UNITED STATES
NUCLEAR REGULATORY COMMISSION
WASHINGTON, D.C. 20555-0001

SUBJECT: MONTICELLO NUCLEAR GENERATING PLANT– SAFETY EVALUATION REGARDING IMPLEMENTATION OF MITIGATING STRATEGIES AND RELIABLE SPENT FUEL POOL INSTRUMENTATION RELATED TO ORDERS EA-12-049 AND EA-12-051 (CAC NOS. MF0923 AND MF0924; EPID NOS. L-2013-JLD-0015 AND L-2013-JLD-0016)

Enclosure:
Safety Evaluation

In the licensee's letter dated February 20, 2017, a sketch was provided depicting the SFP levels of monitoring. The sketch was titled "Figure 1-1 - Spent Fuel Pool Levels (Revised)," and is reproduced below:

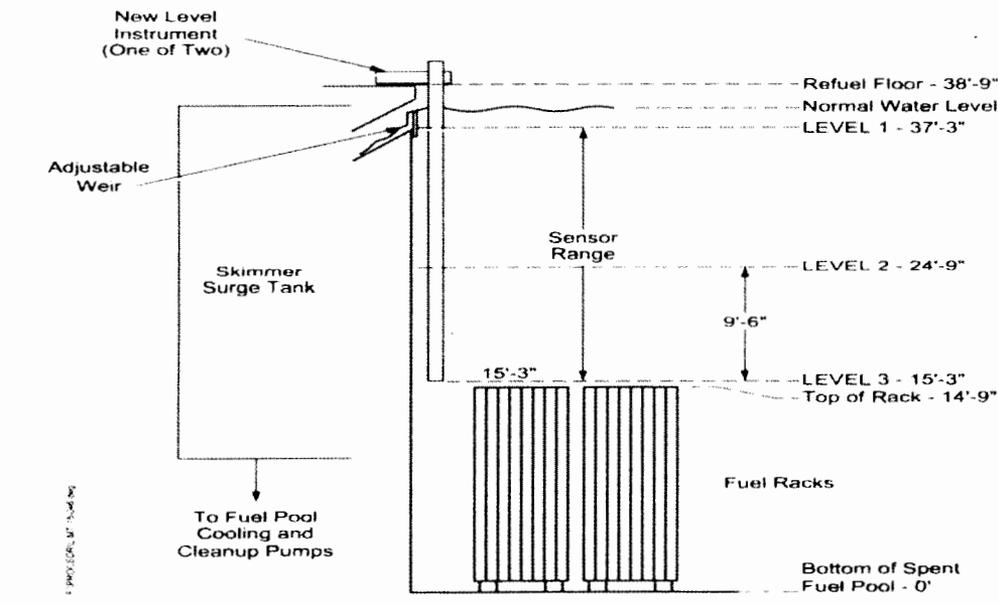
The staff performed an onsite audit to review the implementation of SFP level instrumentation related to Order EA-12-051 at Monticello. The scope of the audit included verification of whether the: (a) site's seismic and environmental conditions are enveloped by the equipment qualifications, (b) equipment installation met the order requirements and vendor's recommendations, and (c) program features met the order requirements. By letter dated March 17, 2015 [Reference 22], the NRC issued an audit report on the licensee's progress.
